**Medway Planning & Economic Development Board
Meeting**

Phytopia Public Hearing Continuation
Major Site Plan, Reduced Parking
Special Permit and Groundwater
Protection Special Permit

RE: **Public Hearing Continuation for Phytopia, Inc - Major Site Plan, Groundwater Protection Special Permit, and Reduced Parking Special Permit**
Continuation Date -- Tuesday, July 12, 2022

**Re: Phytopia Inc.
 Major Site Plan Review
 6 Industrial Park Road
 Medway, Massachusetts**

DRAWING: C6.1

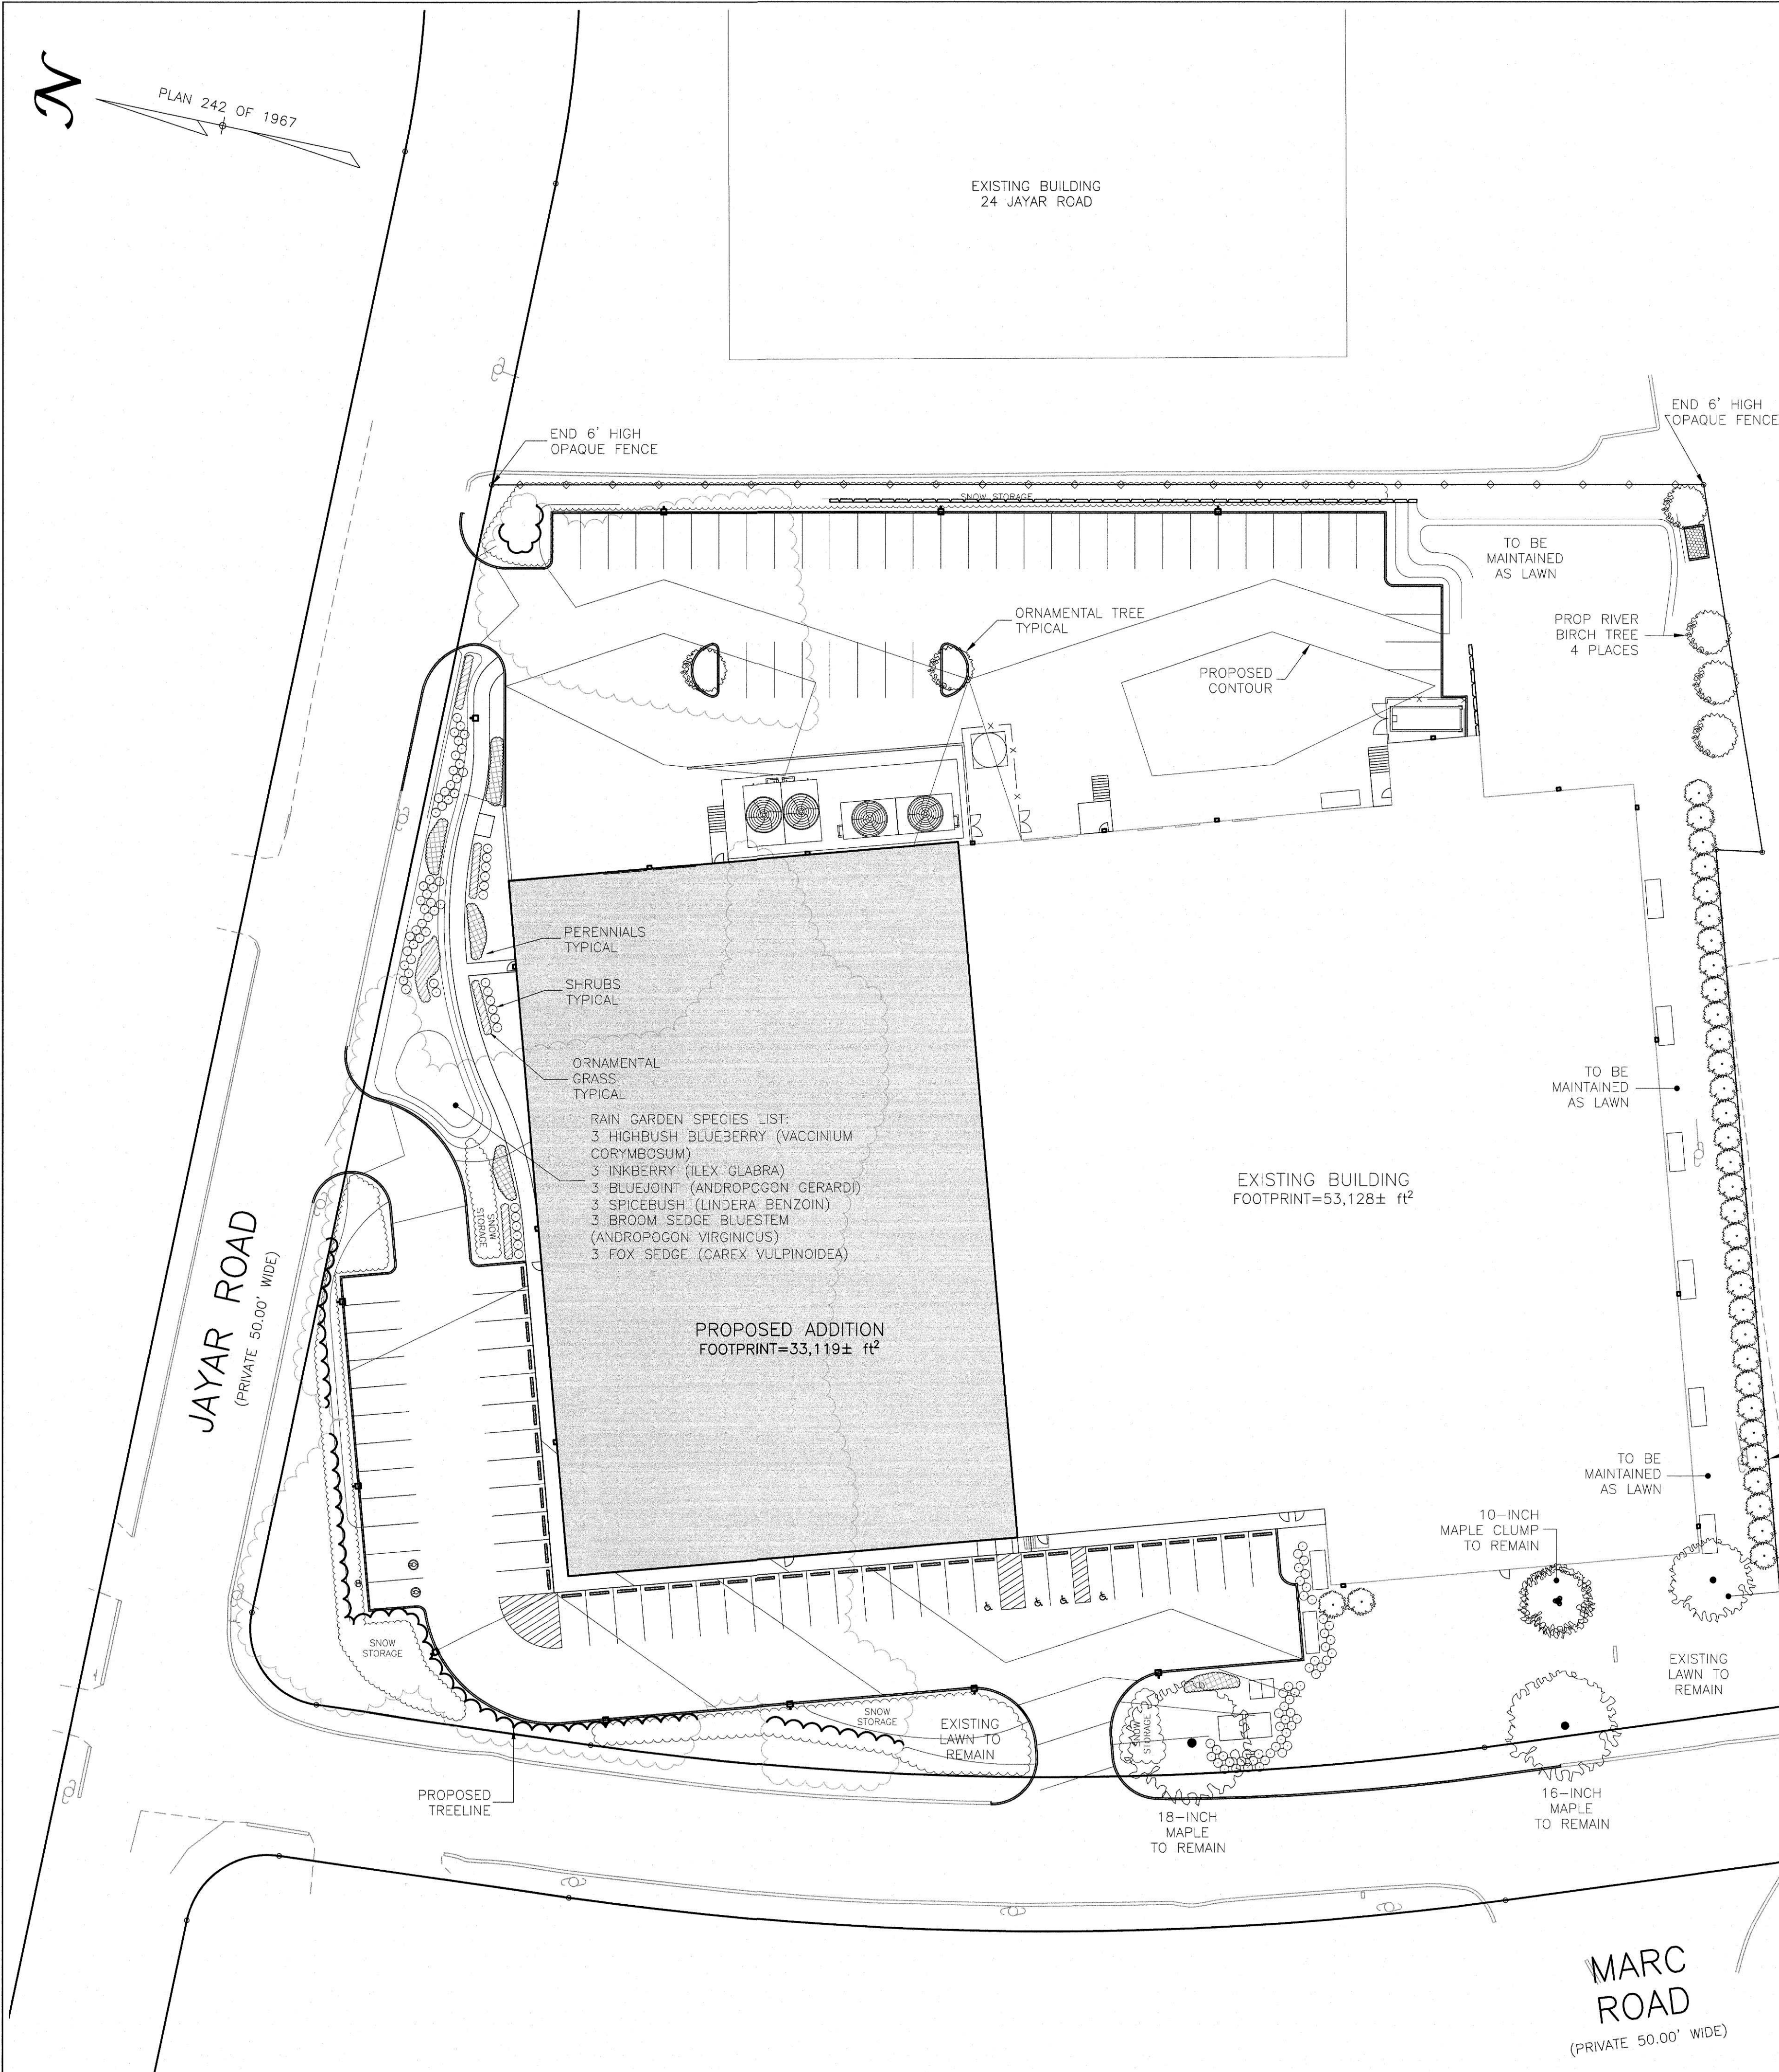
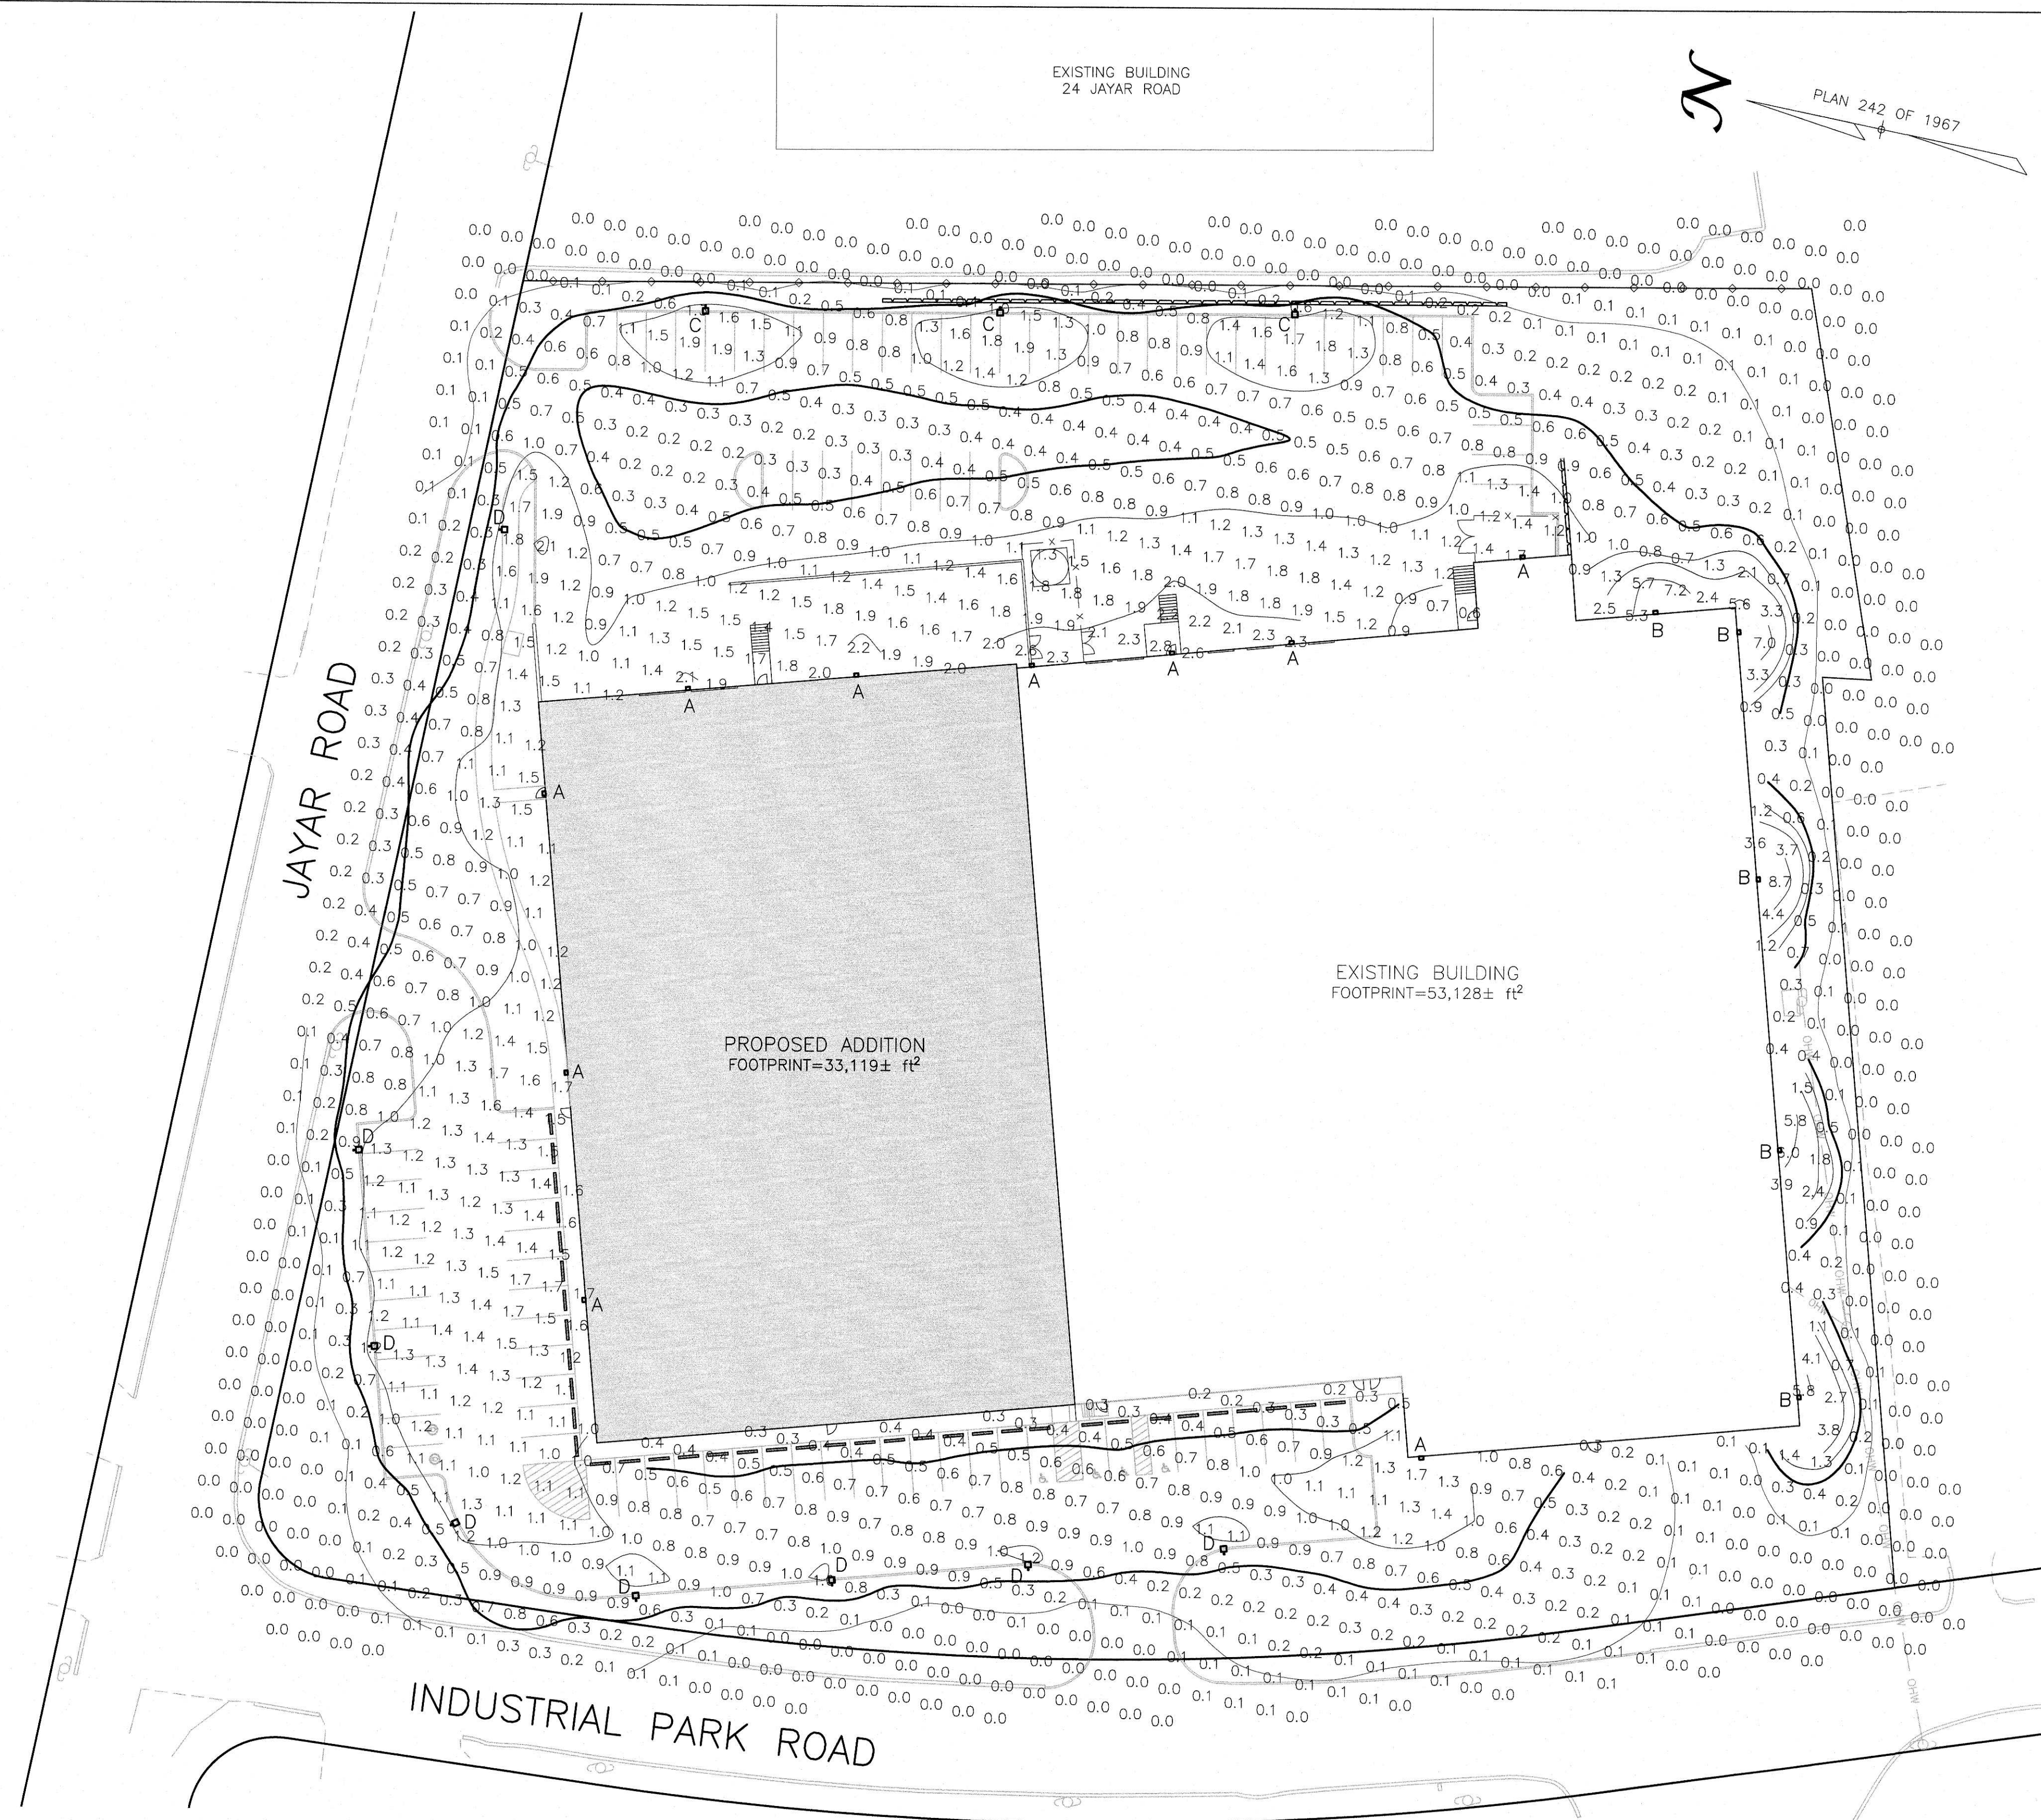
27. The Photometric Plan does not show any light levels beyond the property lines. We anticipate light trespass along the northwestern and northeastern and eastern property lines. (Ch. 200 §207-18)

- *WSE 10/12/21 Response: The Photometric Plan has been revised to show light levels beyond the property line.*
 - **TT 10/27/21 Update: Light trespass occurs along each of the property lines to multiple abutters.**

- *WSE 4/12/22 Response: The lighting design has been revised to eliminate light trespass on abutting properties. Please see revised Photometric Plan.*
